Appl. No.: 09/855,042
Amdt. dated 04 JAN 2006
Reply to Office Action of 30 Dec 2005

III. AMENDMENTS TO THE DRAWINGS:

Amdt. Dated 04 JAN 2006
Reply to Office Action of Dec. 30, 2005
Annotated Sheet Showing Changes

FIG. 1
(PRIOR ART)

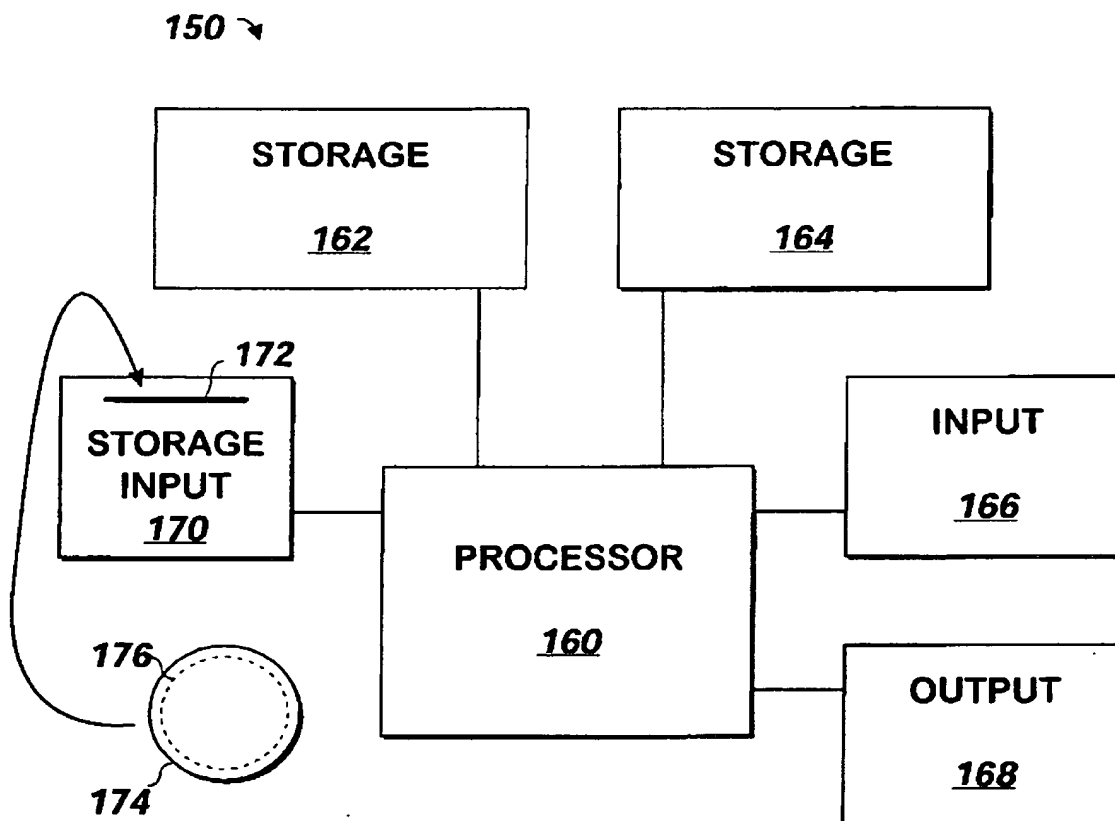
In paragraph 3 of the Office Action, Figure 1 is objected to because element 174 is not coupled to the other elements. In response, Assignee has amended Figure 1 with an arrow showing element 174, referring to a computer program product, input into storage input device 170 via input 172. See Present Specification at page 5, lines 5-10. With these changes, Assignee respectfully requests that the objection to the drawings be reconsidered and withdrawn.

Please accept the attached sheet of proposed drawing corrections including changes to Figure 1. This sheet replaces the sheet of formal drawings filed with the application. In Figure 1, element 174 has been coupled to other elements by an arrow showing element 174 as input into element 172.
